Silver King Mines, Inc.

RE: GWC; 135,85

We would like to make the indicated changes in our Byproduct Materials License Number 40-23111-01, to move the storage location of the sealed sources, and to reflect the current status due to employee turnover. Enclosed is our Check No. 301731 in the amount of \$60.00, to cover the cost of processing this amendment.

Figure 1

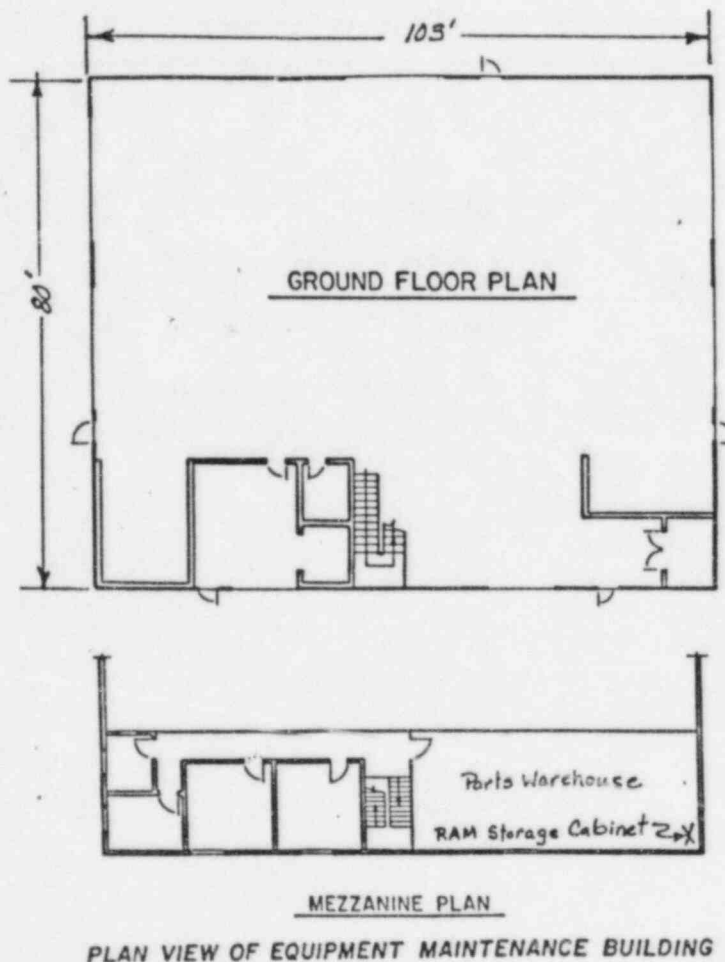
Item 13b: Attached Sheet No. 7 of the original application:

Please replace the original 'Attached Sheet No. 7' with 'Attached Sheet No. 7/R-1', which is enclosed with this license amendment request.

The change in storage location is necessary because the building presently used for storage is scheduled for demolition this fall. We believe the proposed storage location, described in the enclosure (Attached Sheet No. 7/R-1), provides safety and security equivalent to the original location and will not increase exposure to personnel.

The storage facility is an upright steel storage cabinet with locking doors. The cabinet is located in the Parts Warehouse on the Mezzanine level of the Equipment Maintenance Building as indicated in Figure 1. The cabinet is firmly bolted to the wall of the building. The Resident Manager and RSO maintain control of the cabinet keys and access to the sources. All exterior doors of the Equipment Maintenance Building lock and are locked except during business hours.

The sources are stored in the shipping/storage containers identified in Item No. 9. Special shielding is not used. Rooms on the Mezzanine level, excluding the Parts Warehouse, are occupied approximately 96 man-hours per week. The Parts Warehouse is occupied less than 15 man-hours per week.
